SUBJECT: Forwards revised FSAR figures documenting analyses of SER
 Confirmatory Issue 1 re final pipe break locations & design
 of pipe whip restraints. Final break locations based on
 completion of as-built programs & final stress analysis.

August 8, 1983
G02-83-705

Subject: NUCLEAR PROJECT NO. 2
SAFETY EVALUATION REPORT, CONFIRMATORY
ISSUE (1) BREAK LOCATIONS

The subject confirmatory issue requires submittal of the results of analyses to determine final pipe break locations and final design of pipe whip restraints. Attached are the revised FSAR figures documenting these analyses. It should be noted that these revisions indicate break locations based on the "status as built" stress analysis with thermal and fatigue loads. The "status as built" is not a final "as built" configuration; however, the Supply System does not anticipate any significant differences. Hence, the stress analysis and resulting pipe break locations in the attached figures, although not based on a final "as built", will not differ significantly from the final break locations. The final break locations will be based on completion of the "as built" program and the final stress analysis. Although no changes ar

WASHINGTON PUBLIC POWER	STANDARD, LIQUID CONTROL	FILED
SUPPLY SYSTEM, NUCLEAR	KINETIC	3.6-19a
PROJECT NO. 2

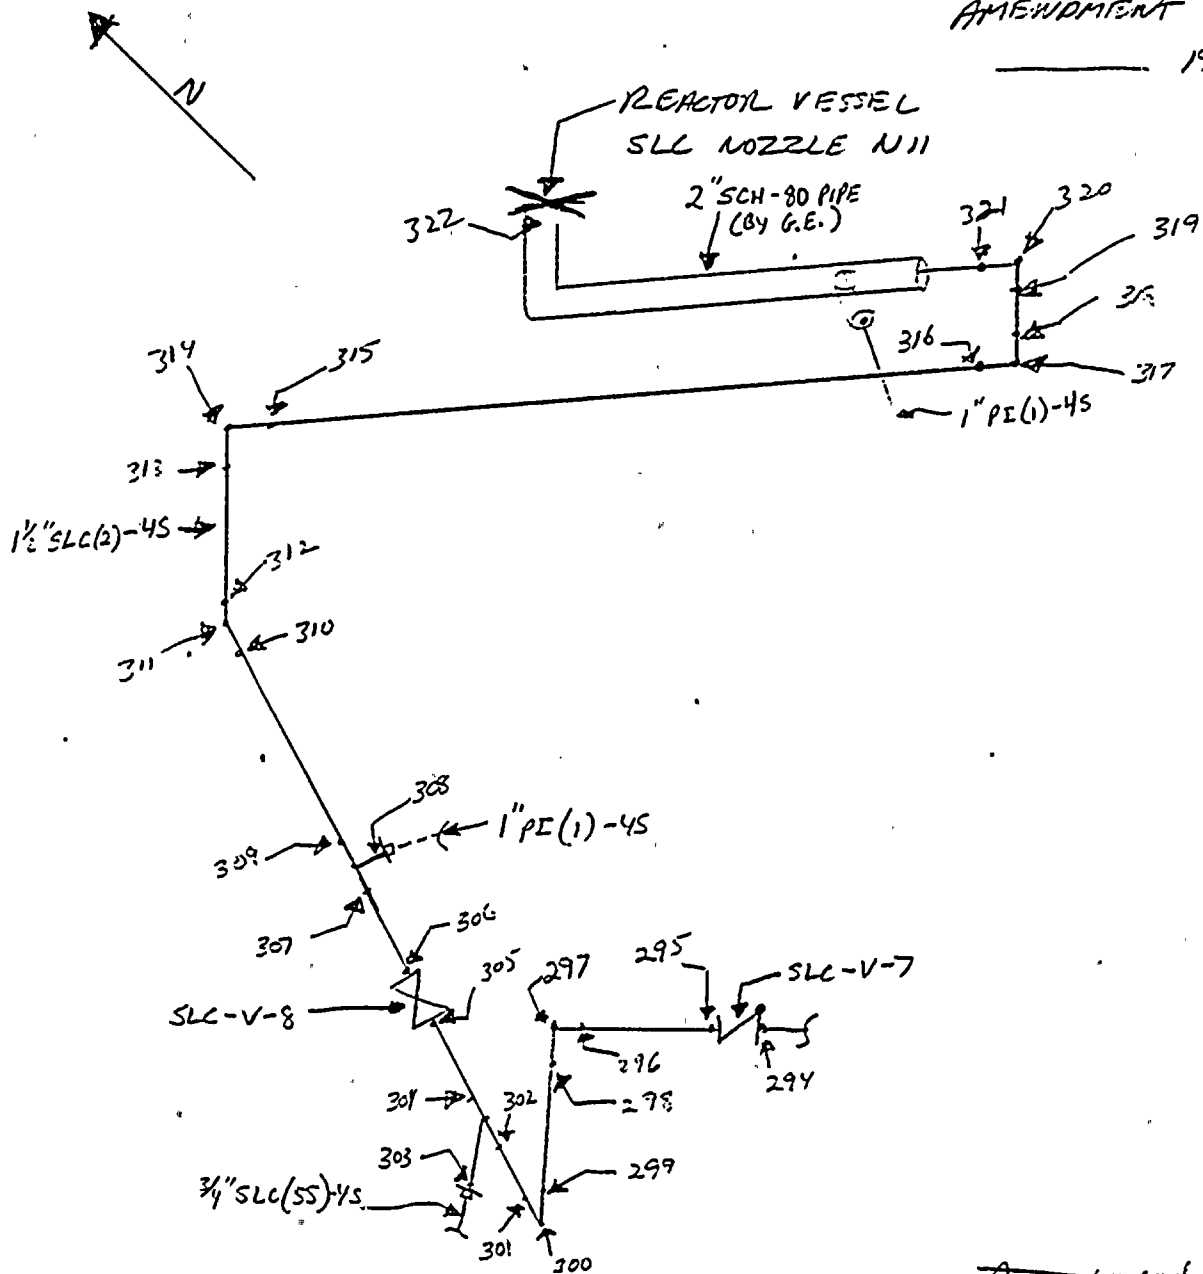
~~Node center of [366, 367, 368] (TEE)~~

~~Node center of [394, 395, 396] (TEE)~~

~~390~~
~~401~~

~~Node center of [389, 389A, 390] (TEE)~~

~~Node center of [380, 381, 381A] (TEE)~~

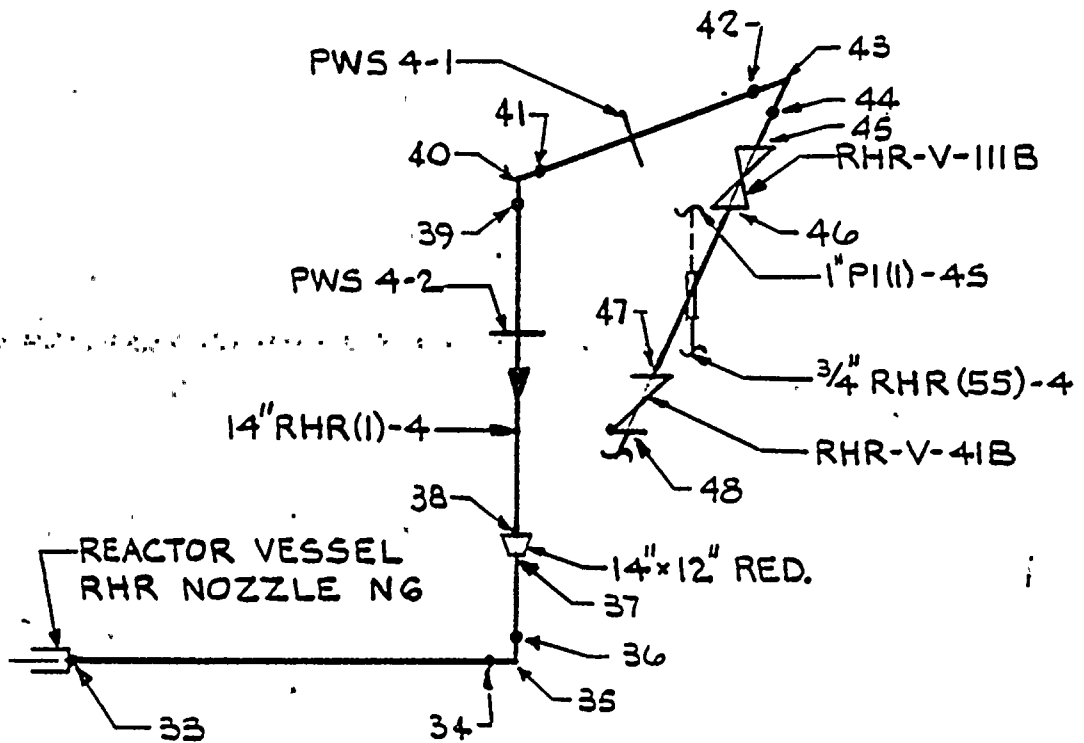
SUMMARY OF POSTULATED PIPE BREAK LOCATIONSCIRCUMFERENTIAL BREAKS

Node 17.
Node 18.
Node 20.
~~Node 21~~
~~Node 22~~
~~Node 23~~
~~Node 25~~
Node 26.
Node 28.
~~Node 29~~
~~Node 30~~
Node 31.

LONGITUDINAL BREAKS

Node 19.
~~Node 24~~
Node 27.

WASHINGTON PUBLIC POWER SUPPLY SYSTEM NUCLEAR PROJECT NO. 2	RESIDUAL HEAT REMOVAL LPCI MODE (LOOP C) ISOMETRIC	FIGURE 3.6-22a
--	--	-------------------

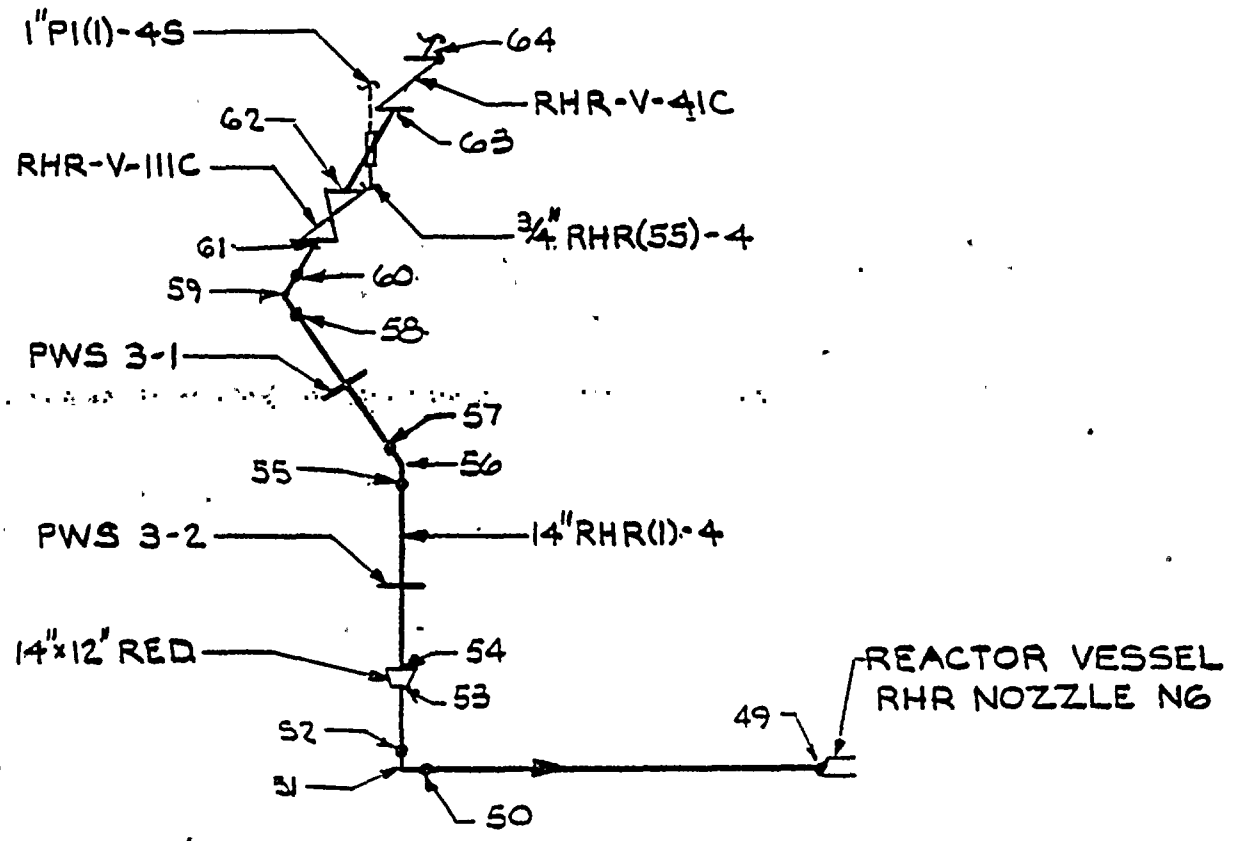
SUMMARY OF POSTULATED PIPE BREAK LOCATIONSPERIPHERAL BREAKS

~~Node 37•~~~~Node 38•~~~~Node 39•~~~~Node 41•~~

~~Node 45•~~~~Node 46•~~

LONGITUDINAL BREAKS

~~Node 40•~~

FIGURE
3.6-24a

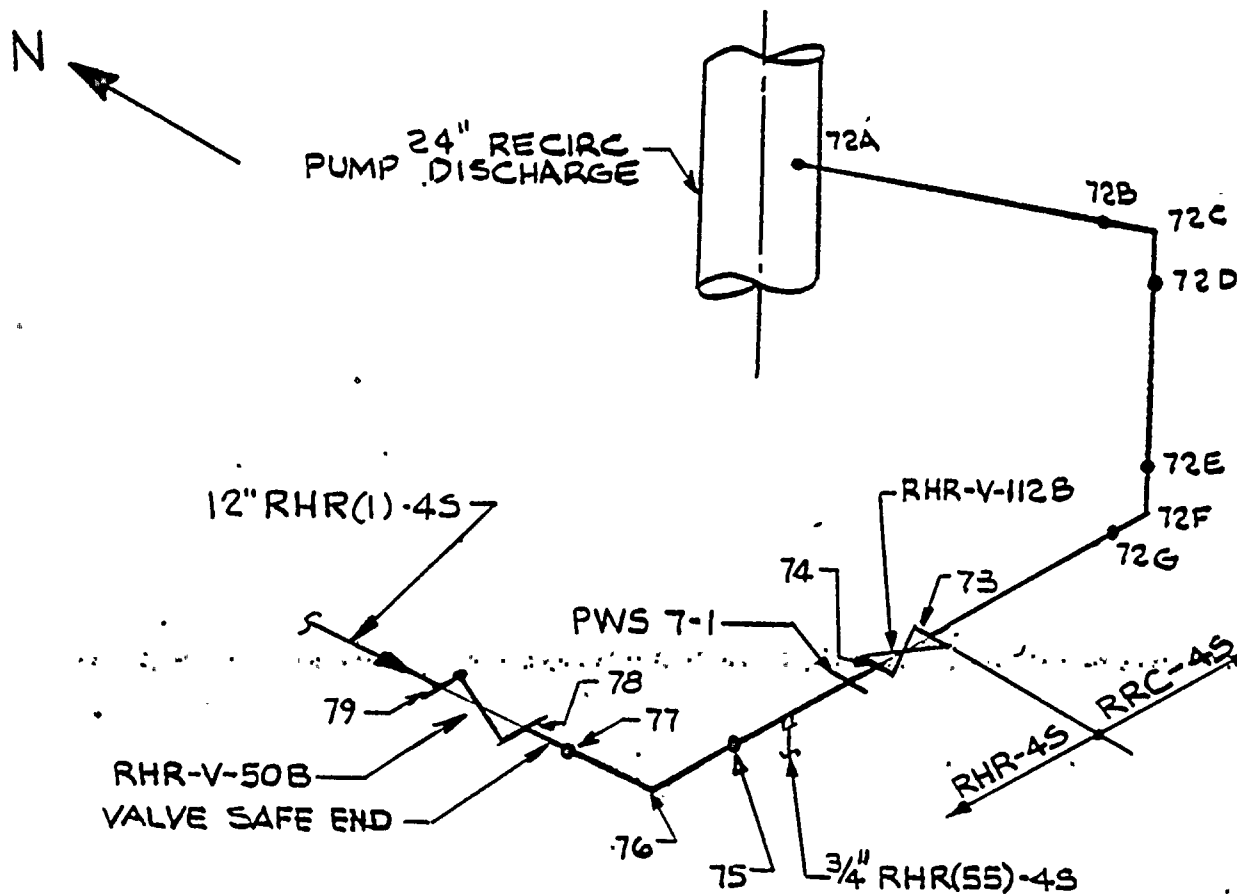
SUMMARY OF POSTULATED PIPE BREAK LOCATIONSCIRCUMFERENTIAL BREAKS

Node 65•
Node 65A•
Node 65C•
~~Node 65D•~~
~~Node 65F•~~
Node 65G•
Node 66•
Node 67•
Node 69•
~~Node 71•~~
NODE 70

LONGITUDINAL BREAKS

Node 65B•
~~Node 65E~~
Node 68•

FIGURE
3.6-
26b

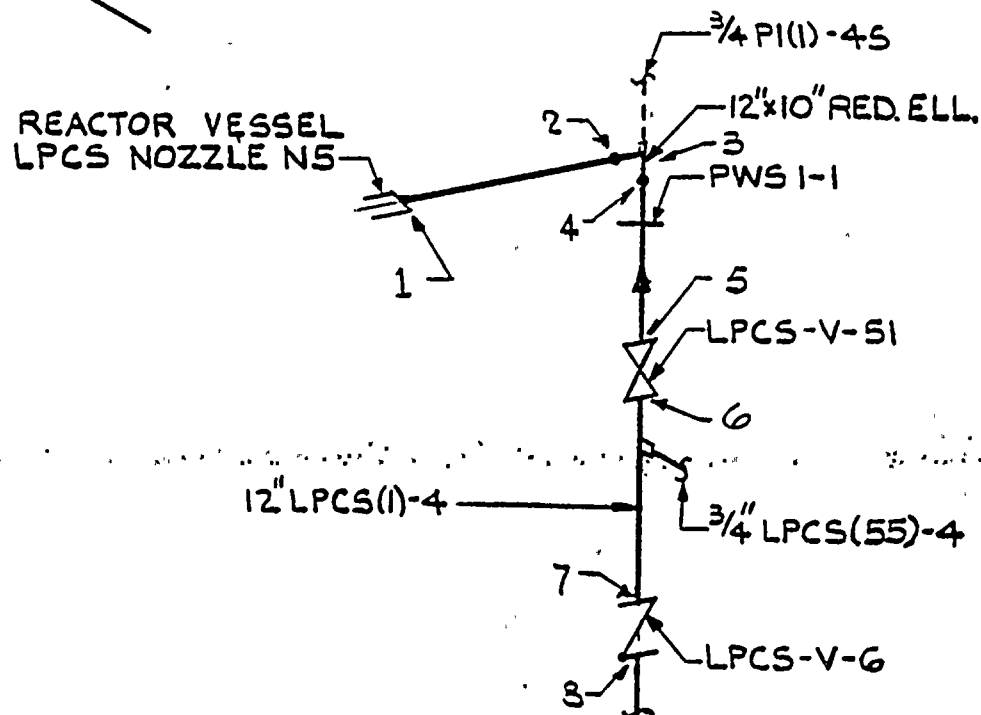
SUMMARY OF POSTULATED PIPE BREAK LOCATIONS

CIRCUMFERENTIAL BREAKS

Node 622*
Node 623*
Node 625*
Node 626*

LONGITUDINAL BREAKS

Node 624*

RCIC RPV HEAD SPRAY ~~SHUTDOWN~~

~~RESIDUAL HEAT REMOVAL SHUTDOWN~~
~~COOLING SUPPLY~~

FIGURE
N.C-31a

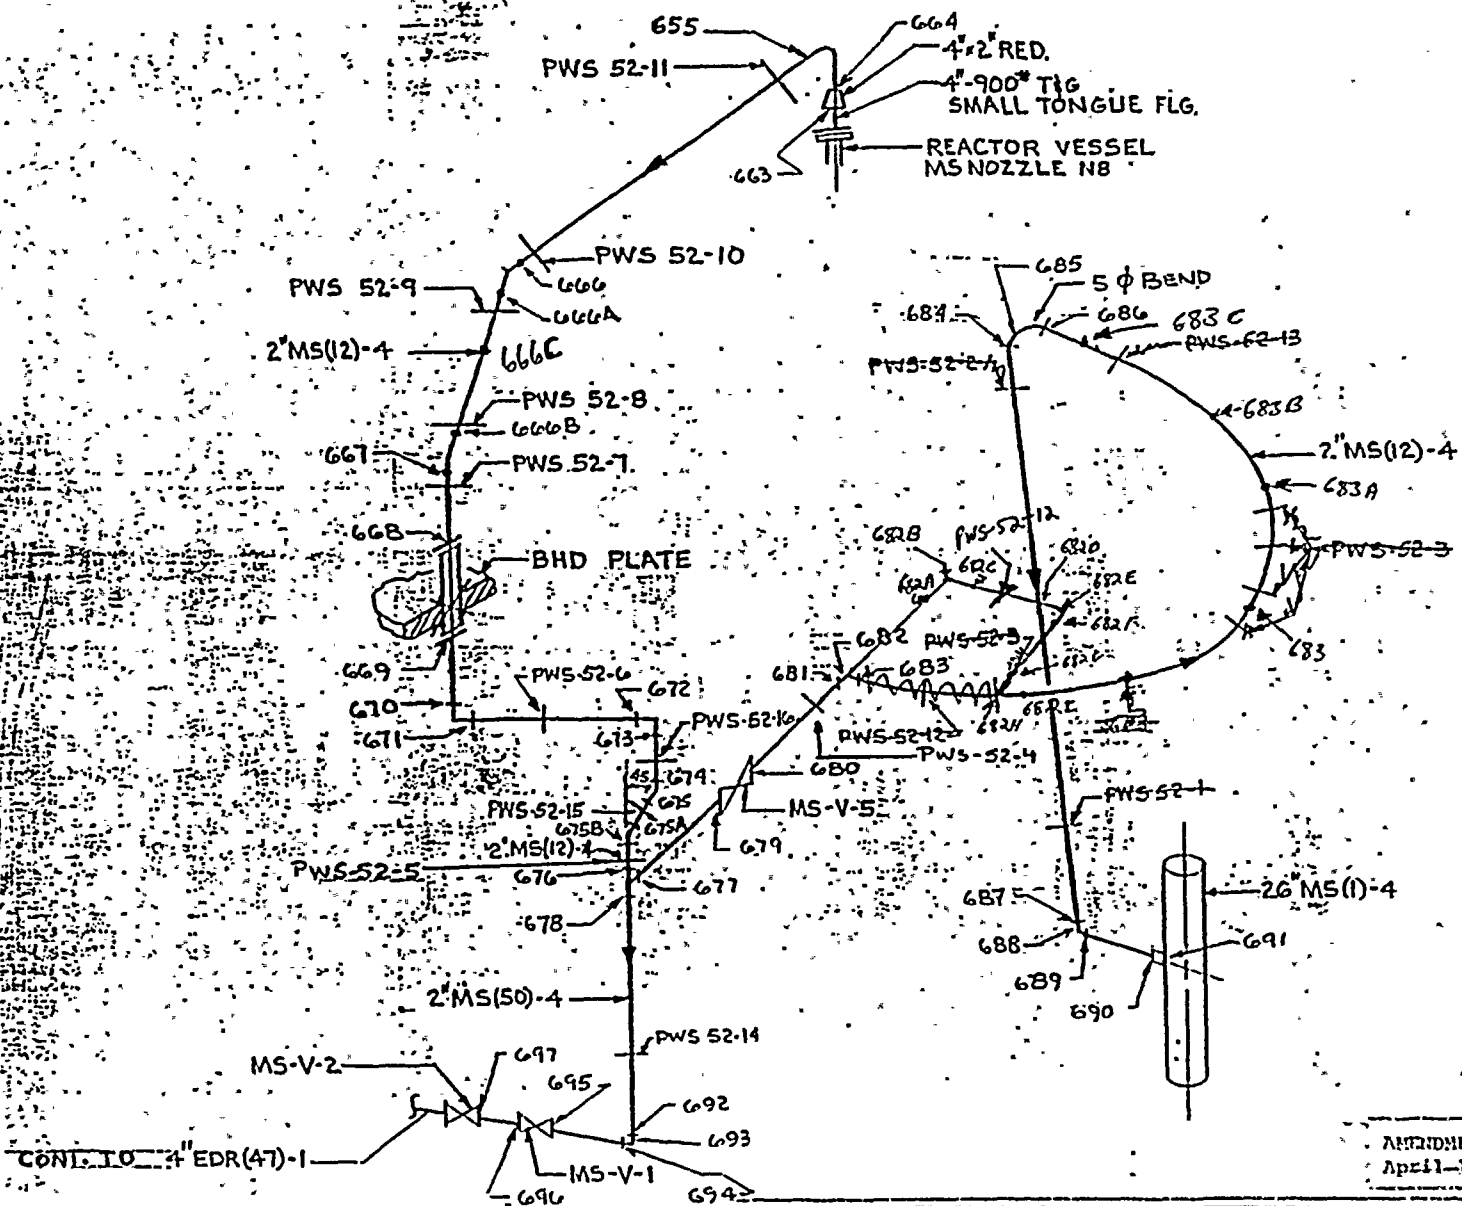
SUMMARY OF POSTULATED PIPE BREAK LOCATIONSCIRCUMFERENTIAL BREAKS

Node 541	Node 557•	Node 574•
Node 542	Node 558	Node 576•
Node 543•	Node 559	Node 577•
Node 544	Node 560•	Node 578
Node 545	Node 562•	Node 579
Node 546	Node 563 NODE 563•	Node 580•
Node 547	Node 565•	Node 582•
Node 549	Node 566•	Node 583•
Node 550•	Node 568•	Node 585•
Node 551	Node 569•	Node 586•
Node 553	Node 570•	Node 588•
Node 554•	Node 571	Node 589•
Node 556•	Node 573

FIGURE
3.6-32a

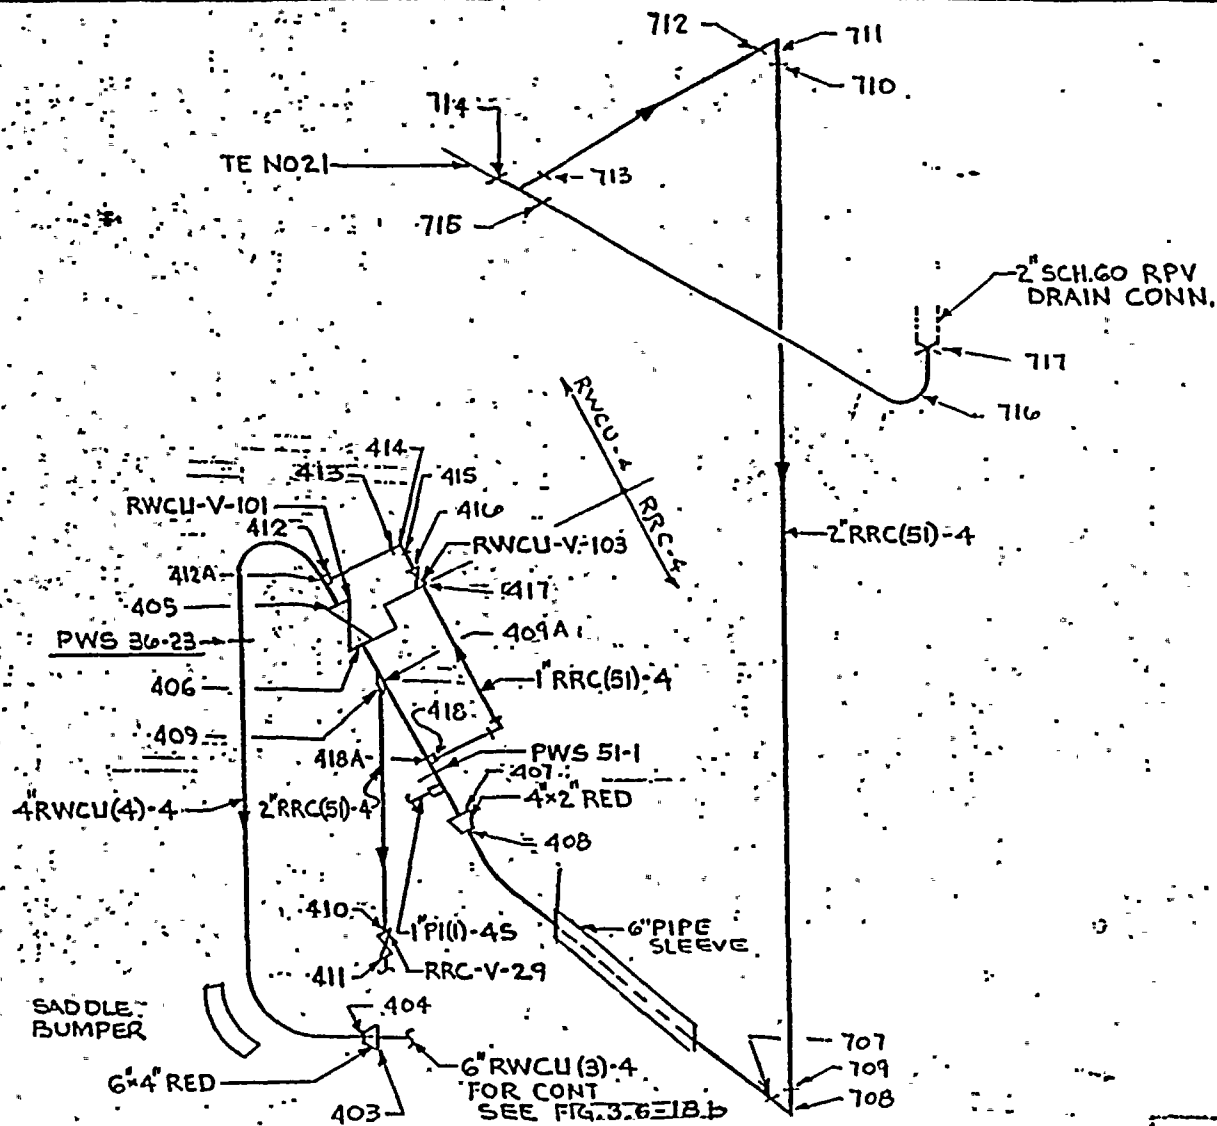
SUMMARY OF POSTULATED PIPE BREAK LOCATIONSCIRCUMFERENTIAL BREAKS

Node 663 •
~~Node 664~~
~~Node 666~~
~~Node 666A~~
~~Node 666B~~
~~Node 667~~
Node 668 •
~~Node 669~~
~~Node 670~~
~~Node 671~~
~~Node 672~~
~~Node 673~~
~~Node 674~~
~~Node 675~~
Node 675A •
Node 675B •
NODE 666C

Node 676 •
Node 677 •
Node 678 •
Node 679 •
~~Node 680~~
~~Node 681~~
Node 683 •
~~Node 687~~
~~Node 689~~
Node 690 •
~~Node 692~~
~~Node 694~~
Node 695 •
~~Node 696~~
~~Node 697~~
~~Node 698~~
NODE 682A
NODE 682C
NODE 682D
NODE 682F
NODE 682G
NODE 682I
~~NODE 683~~
NODE 683A
NODE 683B
NODE 683C

3.6-326.

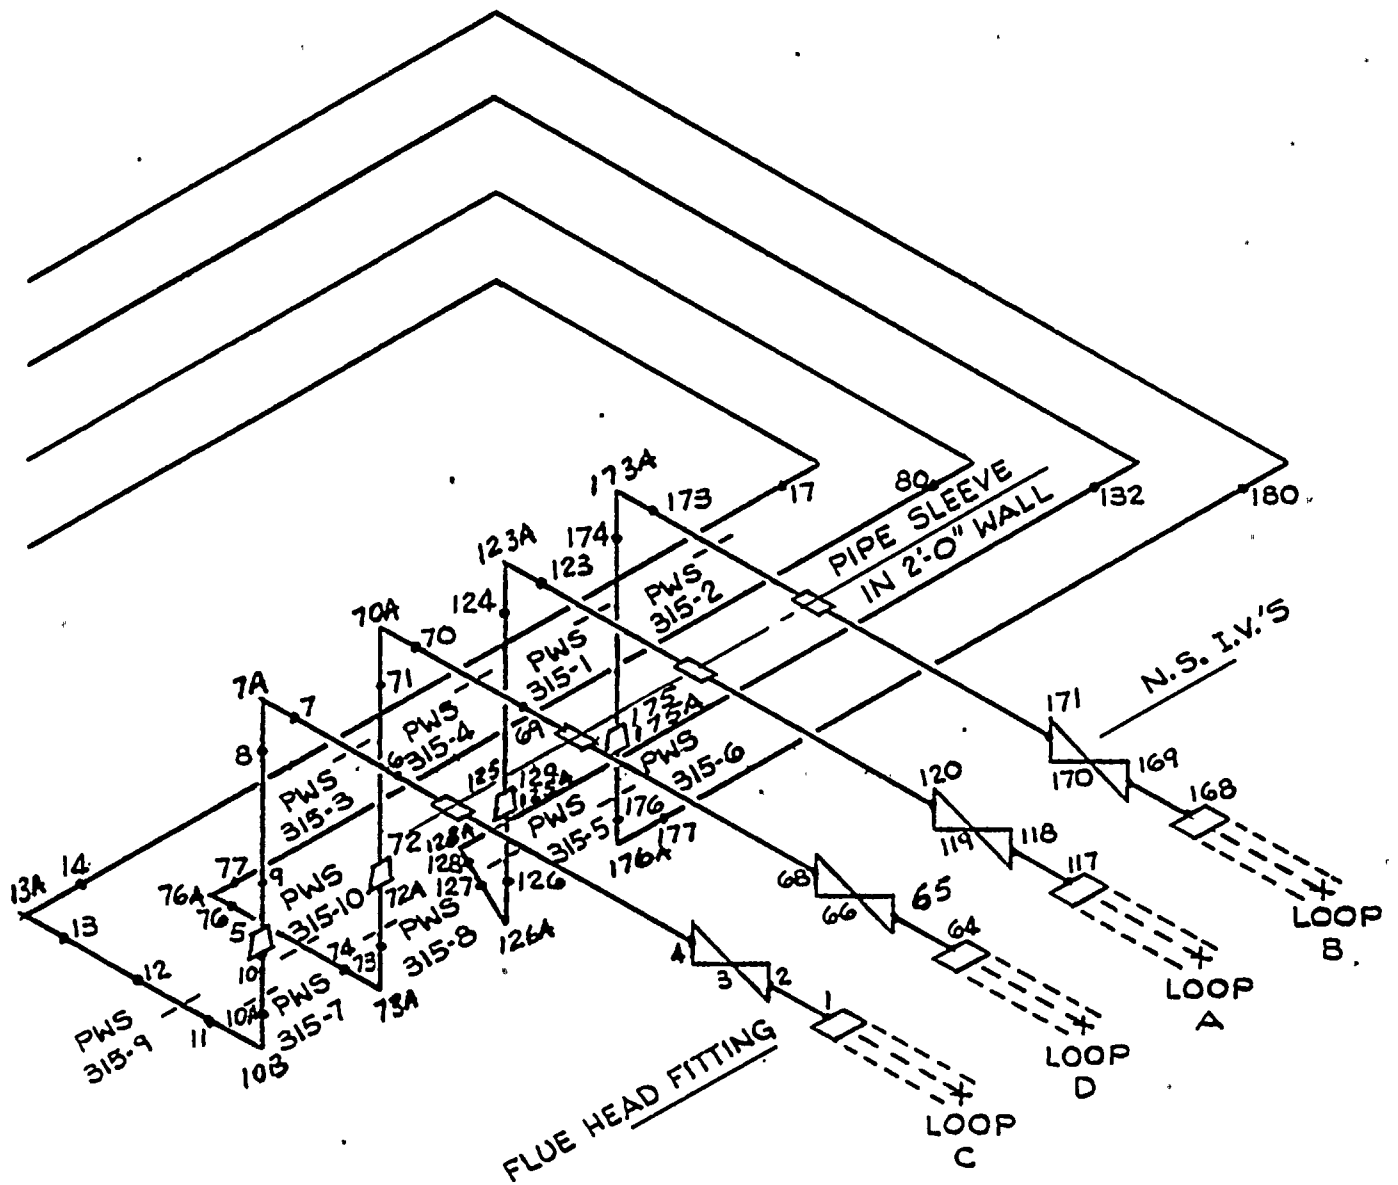
SUMMARY OF PIPE BREAK LOCATIONS.

CIRCUMFERENTIAL BREAK.

NODE 717
NODE 715
NODE 713
NODE 410
NODE 409
NODE 418
NODE 416
